Clause 184 functions (supporting comments 243- 247, 249, 250, 252)

Tom Huber, Nokia

- Clause 184 defines the inner FEC and PMA for 800GBASE-LR1 using pseudocode to describe the processes in 184.4 and 184.5
- Multiple comments were submitted against D1.0 with the intention to simplify the pseudocode; these were rejected on the basis that:
 - The text was technically correct, unambiguous, and came from the baseline slides
 - It would be better to have a more complete proposal before making any changes (in particular wrt how changes to one subclause might impact a subsequent subclause)
- This presentation provides a more complete proposal in support of comments 243-247, 249, 250, and 252

Remaining functions are per-lane

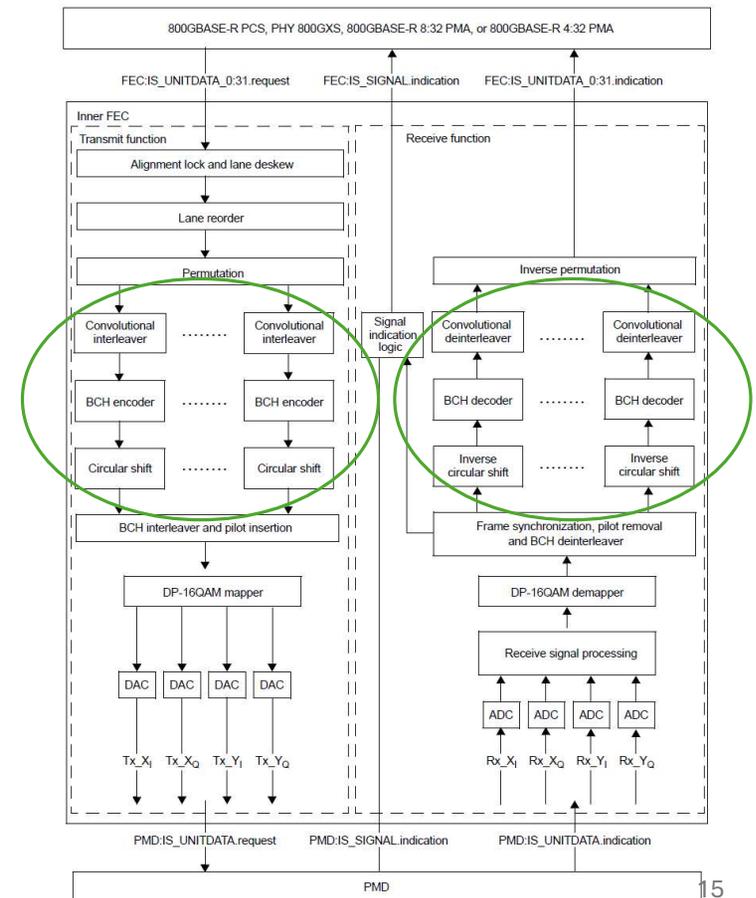
- Per figure 184-2, the functions between lane permutation and interleaving into the BCH FEC frame are performed separately on each lane
- Corresponding pseudocode should describe the processing for a single lane, not the set of 32 lanes
